SUBJECT: Referral to Development Engineer for Comments

DESCRIPTION: Subdivision to create 191 Torrens title lots, two open spaces, landscaping, associated roads and infrastructure

DEVELOPMENT ENGINEERING REFERRAL

DA.2025.0303 – Subdivision to create 191 Torrens Title lots, open space, associated roads and infrastructure.

Figure 5: Water pressure zones

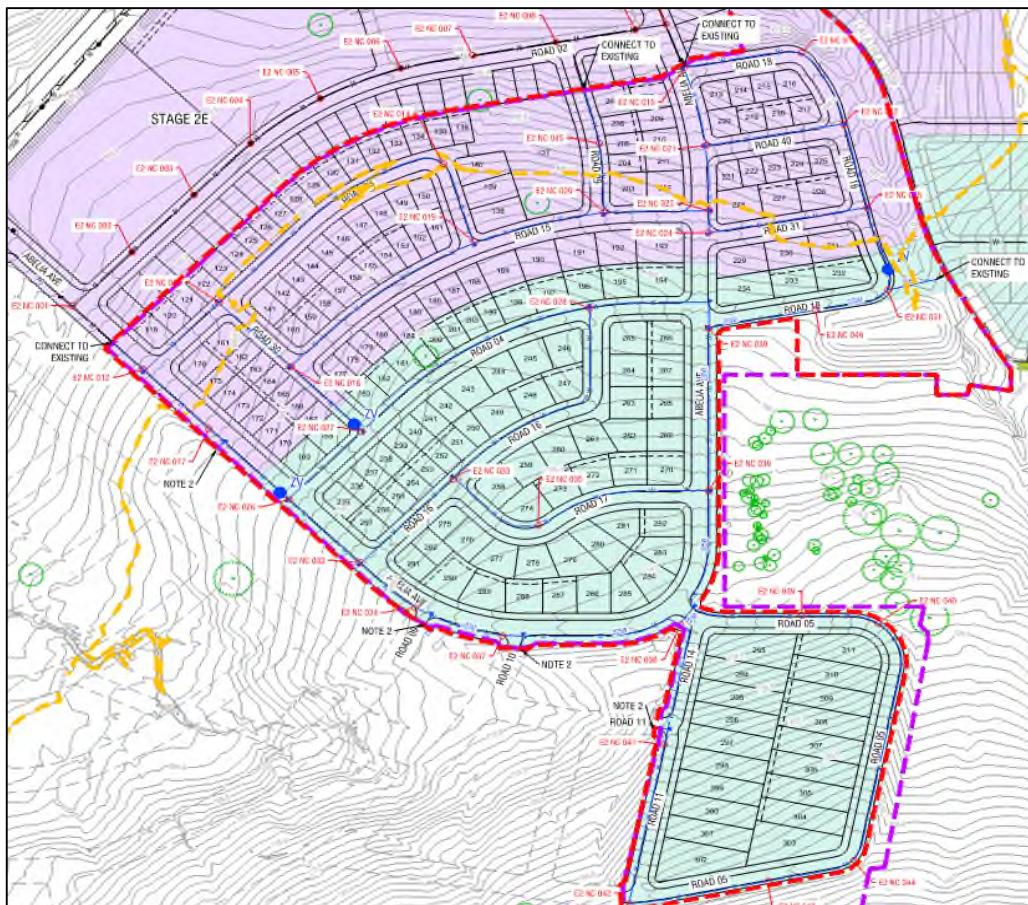
South Jerrabomberra Estate 2 comprises two pressure zones, a High Zone and an Intermediate Zone, see figure 5. Both zones are proposed to be utilised for the stages proposed as part of this application. The southern half of the development will be within the high-pressure zone, to be serviced from the high-level reservoir. A 225mm Ø stub was provided to the stage boundary, off Calathea Loop, as part of the Stage 2B works. Mains will extend from this to service the high-pressure zones within the area covered by this application.

The Northern half of the development will be within the intermediate zone and will be serviced from the existing water reticulation from Estate 2, Stage 2C and 2E. Three zone valves are proposed throughout the development as part of this application, see figure 5.

The pressure at various nodes within the proposed subdivision is provided as part of the supporting documents submitted. The pressure ranges from 35.76m head (350.45kPa) to 83.57m head (818.99kPa) throughout the subdivision. It is noted that the maximum pressure exceeds the allowable maximum of 800kPa as outlined in QPRC's D11 Water Reticulation specification. This occurs once throughout the development, at node E2 NC 031, with all other nodes satisfying the maximum pressure requirements of Council's D11 specification. AS3500, Part 3.3.4 specifies that the maximum pressure at any outlet, other than a fire service outlet, within a building should not exceed 500kPa. As such, a pressure reducing valve at the reticulation or at the service connection will be required to limit pressure to 500kPa.

A detailed hydraulic plan will need to be submitted as part of the subdivision works certificate application to confirm compliance with all relevant criteria of QPRC D11 specifications, and where specified, relevant WSAA and Australian Standards.

Figure 6: Sewer – General Arrangement

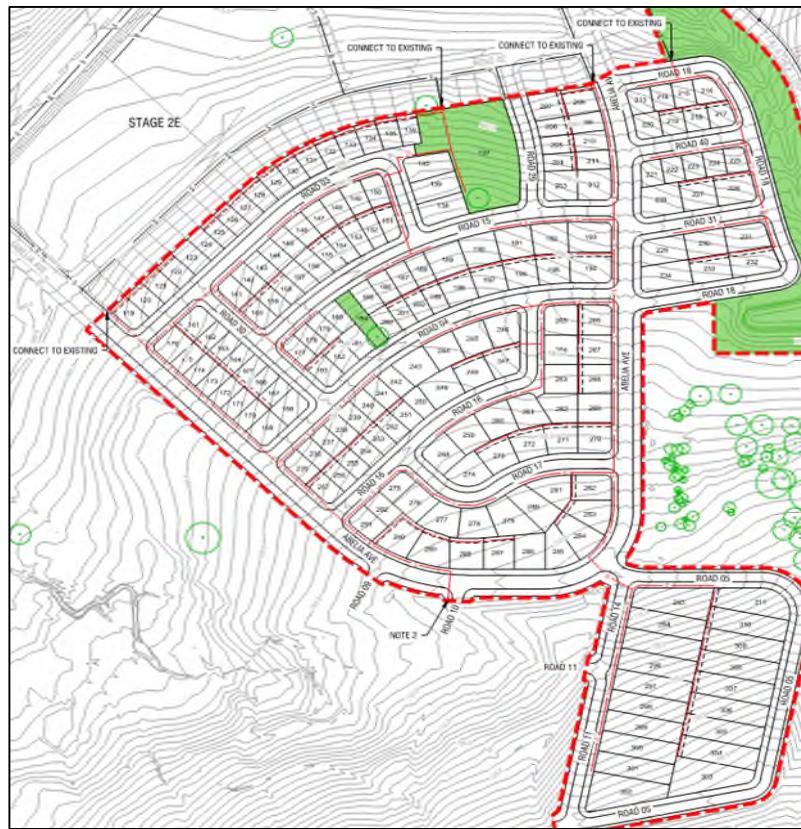
The development is proposed to be serviced by a gravity network that will flow to the existing sewer main at several locations. These include:

- 150mm Ø stub on the North of open space lot 137,
- 150mm Ø stub on the Western verge of Abelia Avenue, adjacent to lot 208,
- 150mm Ø stub on the Northern verge of Road 18, and
- 225mm Ø stub in the Northern Verge of Abelia Avenue.

The mains proposed within the development are 150mm and are predominantly under the footpath. Mains required at the back of blocks are to be located within a shared 3.5m wide sewer and stormwater easement.

A series of nodes within the estate has been used to calculate and confirm the size and grade of the proposed sewer mains. The engineering report and calculations provided have confirmed that the sewer networks have been designed in accordance with QPRC's D12 specifications and WSA02 2014-3.1.

Detailed design confirming the alignment and grade of the sewer mains and individual property connections are to be assessed at the Subdivision Works Certificate stage.

Figure 9: Stormwater General Arrangement

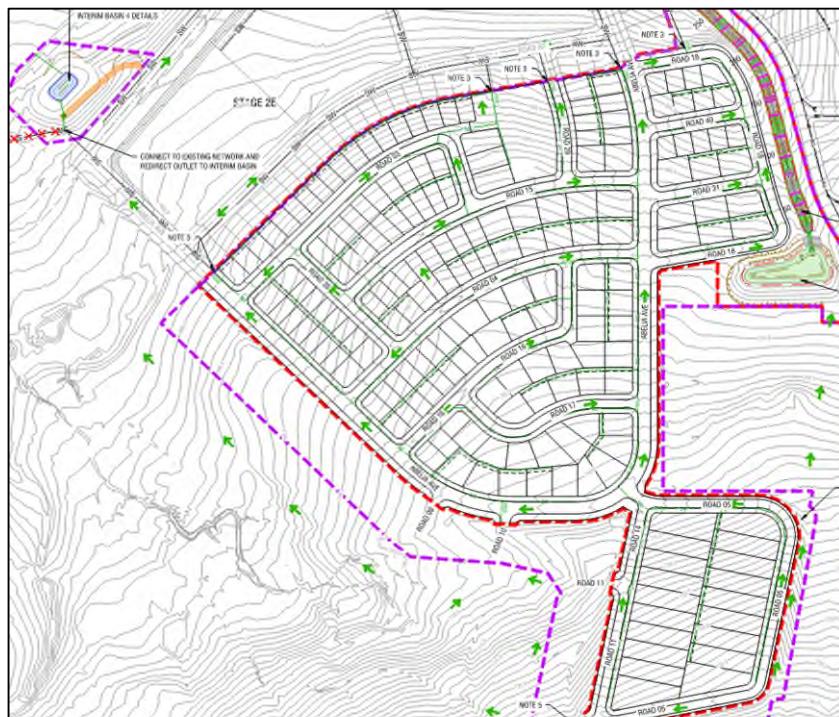
The minor drainage network, i.e. pipe drainage network, is to convey the 20%AEP event flows. The major drainage network, i.e. stormwater flow overland through road reserves, is designed to convey the gap between 1% and 20% AEP events.

The mains are predominantly within the verge. Inter-allotment drainage is proposed where the primary network is unable to service the lot due to topography. Inter-allotment drainage must be located within a stormwater easement, minimum 2.5m wide, or a shared sewer and stormwater easement, minimum 3.5m wide.

The development proposes the construction of an open channel with rock chutes to the East of Road 18, to convey flows from the upstream external catchment, instead of the piped flows as approved under the Estate 2 concept plan, DA.2021.1284. The submitted Civil Engineering report confirms that the flow velocity and depth within the channel meet QPRC's design requirements. A detailed design must be submitted for assessment at the Subdivision Works Certificate stage.

Figure 10: Basin Catchments

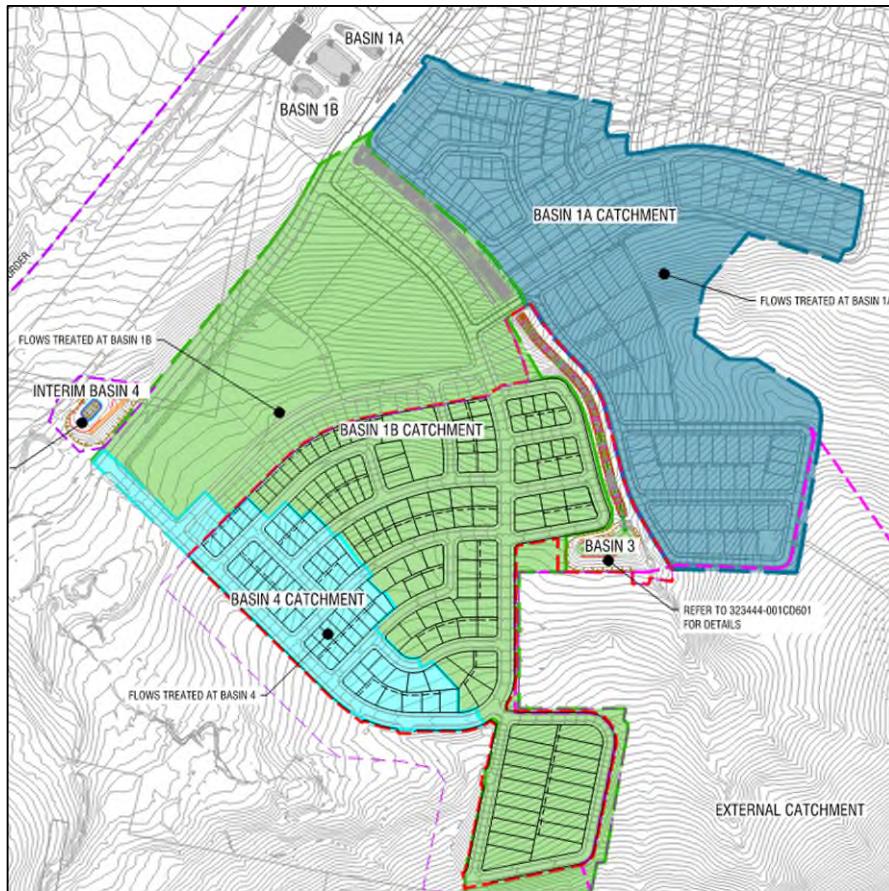
The Central Catchment, see figure 8, is proposed to consist of multiple different land uses. This will increase the overall fraction of impervious area and therefore runoff during rain events.

The Civil Engineering report prepared by SPIIRE, dated 9 July 2025, reflects the revised layout and confirms that the proposed stormwater strategy can meet site discharge requirements through the provision of three basins, Central Basin (1A and 1B), Basin 3 and Interim Basin 4, see figure 10.

The report confirms that the sizes of the proposed basins will ensure the predevelopment discharge rates for 20% and 1% AEP events will not be exceeded. Detailed design of the stormwater network, including pipe details and basin designs, must be submitted for assessment at the Subdivision Works Certificate stage.

Figure 17: Edge Street Cross Section

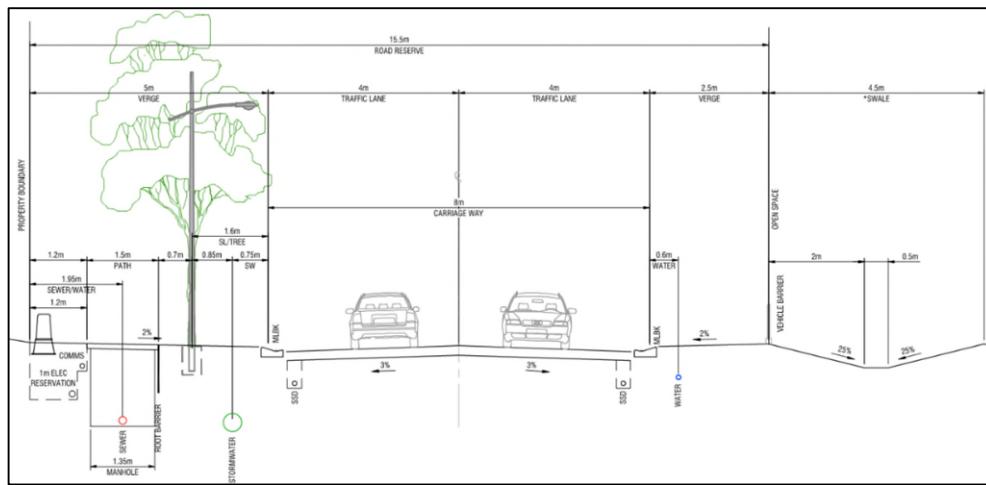
Road 05 and Road 18 are classified as edge streets. These roads have been provided with an 8m pavement width, a 5m verge adjacent to the residential lots and a 2.5m wide verge adjacent to the drainage swale and open spaces. The proposed reduced verge width is not compliant with QPRC's specifications. SPIIRE's engineering report acknowledges this departure from QPRC's design requirements and confirms that the reduced verge will not contain any services except for the water main and will include a vehicle barrier to prevent vehicle access to the drainage swale and other open space areas. A similar approach was used as part of Estate 1 Stage 1D, and Estate 2 Stage 2B. Development Engineering does not generally support reduced verge width as it limits the maintainability of swales and restricts the construction of the footpath in future. The pedestrian path network plan for estate 2 shows a 1.5m wide footpath constructed within the drainage reserve between Speargrass Road and Pandorea Way, to the Northeast of the drainage swale, and a

pedestrian bridge to create a link to the footpath located on Road 18. An email from Village dated 24 September 2025 confirmed that this path and link will be constructed as part of this development. The final alignment of the path is to be confirmed and assessed as part of the Subdivision Works Certificate application.

Figure 18: Intersection Turning Movement Plan

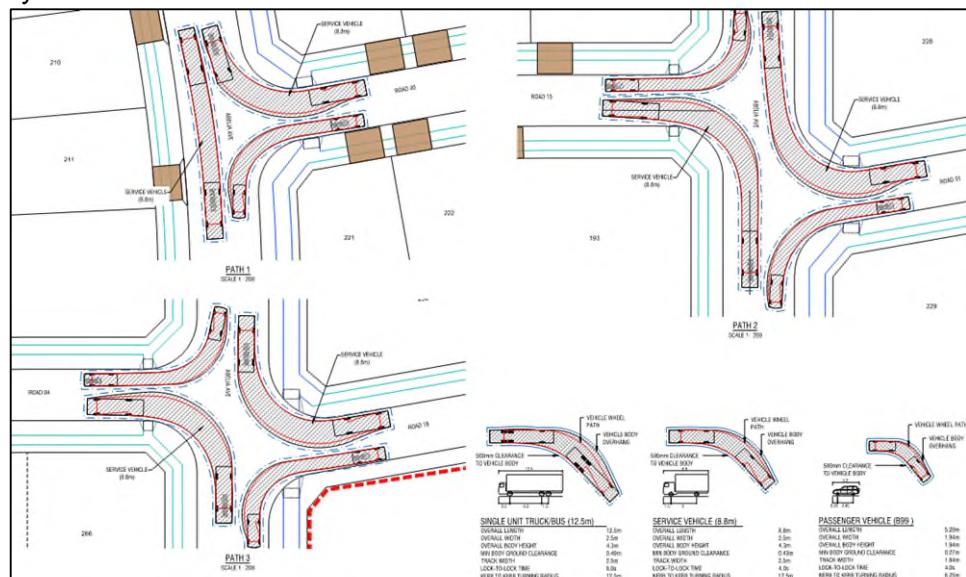
Swept path plans were included in the civil plans submitted with this application. Submitted swept path drawings confirm an 8.8m service vehicle can safely pass a B99 vehicle on all roads at 5km/h, in accordance with Austroads Design Vehicles and Turning Path Templates Guide.

Development Engineering raised concerns over potential conflict points at the Abelia Avenue, Road 05 and Road 14 intersections. The applicant has proposed additional line marking and signage to mitigate the risk of conflicting movements. A detailed line marking and signage plan is to be submitted for assessment by Local Traffic Committee.

Sight distance calculations were submitted as part of this application. The civil engineering report prepared by SPIIRE confirms all sight distances have been completed in accordance with QPRC's D1 specification. The report notes that achieving sight distances in certain locations will require signage to restrict on-street parking. A detailed line marking and signage plan is to be submitted for assessment by the Local Traffic Committee.
